STAFF REPORT Site Plan Review (Type III)

PROPERTY: 1800 28th Court, Coos Bay, OR 97420 (25-13-28 – TL 400)

SUBJECT: **LAND USE APPLICATION #187-19-022**
Construct two steal span buildings for RV/Vehicle Storage
50' x 580' and 60' x 484'

REVISION	DATE	PROJ.	RV Storage #2
A	3/21/19		Coco Bay, OR 97420
	MLW	TITLE	Anchor Bolt Plan
		DEALER	R C Slope Construction Inc

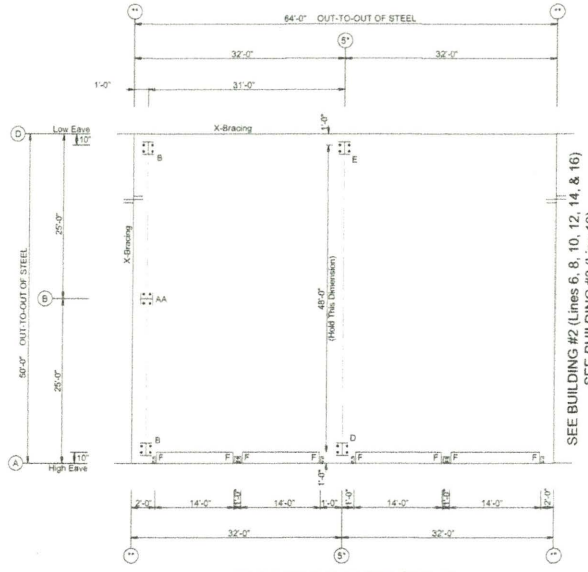
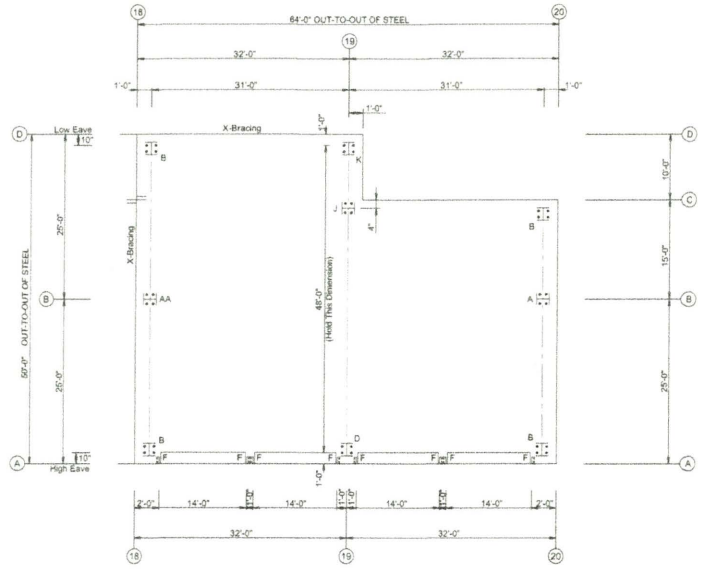
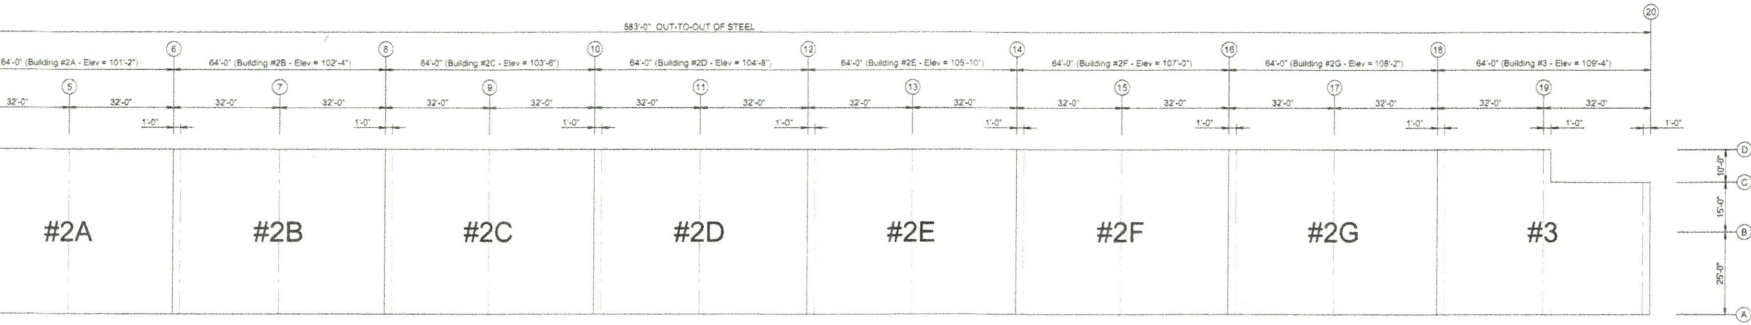
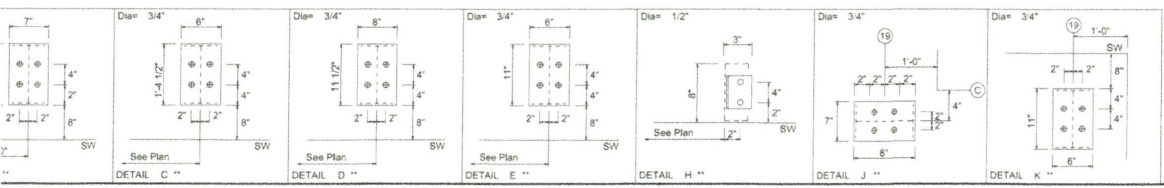
With accessibility, the largest concern was access to the back of the structure. The provided plans were not clear as to the amount of room from the structure to the fence. Because of the length of the building, the OFC requires a 20-foot access road around the back of the structure. Please let me know what your plan is for clearance from the structure to the existing fence line.

The third point of discussion was that of firewalls. The submitted plans seem to indicate fire walls installed every 64 linear feet. Even without enclosing the front of the structure, firewalls are required to reduce horizontal fire spread. Firewalls also reduce the required fire flow (without them the required fire flow increases to 1,750 gpm). The alternative to firewalls would be the installation of an NFPA compliant Automatic Fire Sprinkler system.

- b) Firewalls are required and they reduce the required fire flow (without them the required fire flow increases to 1,750 gpm). The alternative to firewalls would be the installation of an NFPA compliant Automatic Fire Sprinkler system.

- c) The OFC requires a 20-foot access road around the back of the structure
2. The proposed structures shall comply with all building code requirements, including:
